09/25/2020
CAL FTL 54-012

Subject: New Cascadia 29A Battery Cable Relocation

Models Affected: New Cascadia vehicles built from January 1, 2017 through September 18, 2020

Fig. 1, 29A Battery Cable

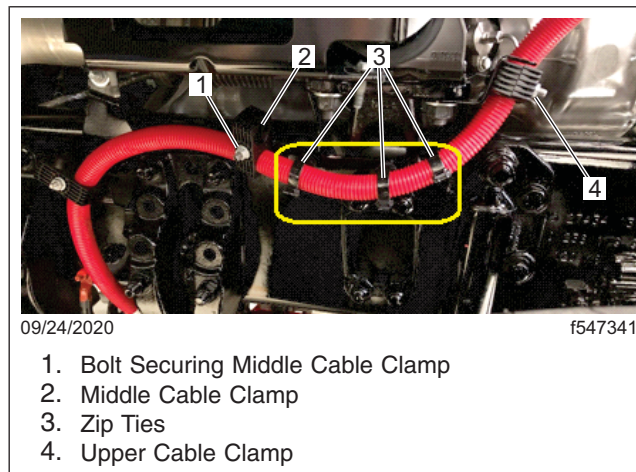
1. Remove the four nuts securing the right inner fender and remove the fender.
2. Carefully cut the zip ties securing the battery cable access (BCA) battery cable as shown in [Fig. 1](#).

3. Remove the nut securing the middle cable clamp. See [Fig. 1](#)) and remove the front piece of the clamp.
4. Loosen but do not remove the nut from the upper cable clamp (see [Fig. 1](#).)
5. Relocate the battery cable from below the stud to above the stud on the middle cable clamp. See [Fig. 2](#) and [Fig. 3](#).

Fig. 5, Secured Battery Cable

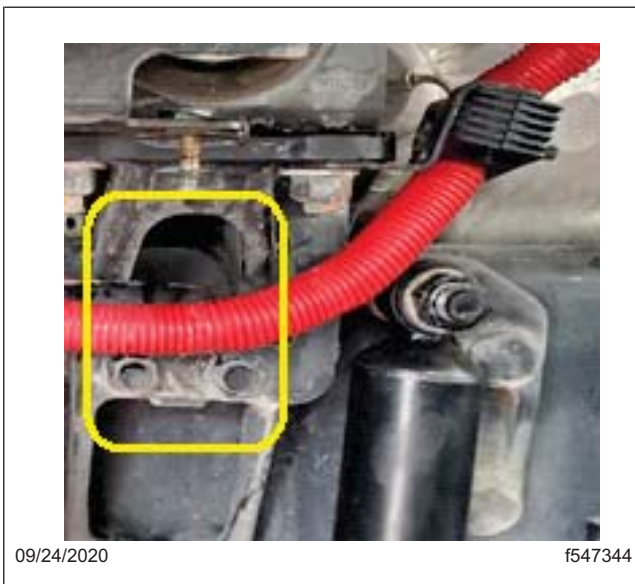
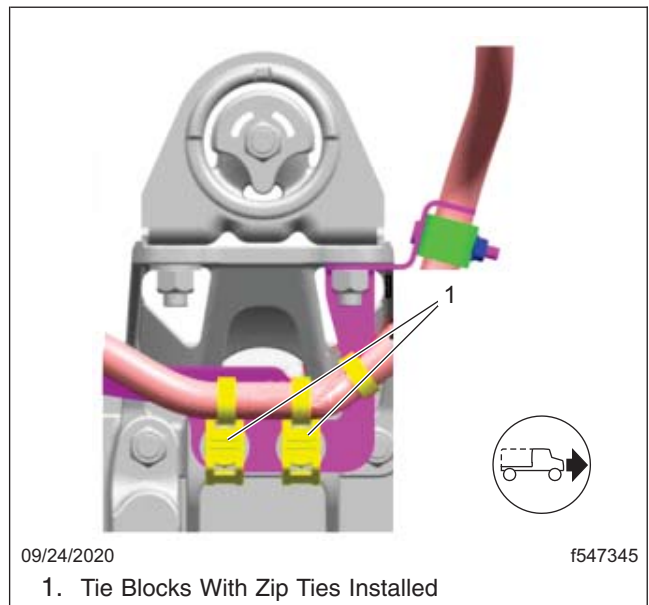
6. Ensuring the cable remains mounted on top of the stud, install the front piece on the middle clamp and secure the nut.
7. Install two tie blocks and two zip ties on the front-cab-mount bracket bolts to prevent rubbing. See [Fig. 4](#) and [Fig. 5](#)

1. Tie Blocks With Zip Ties Installed
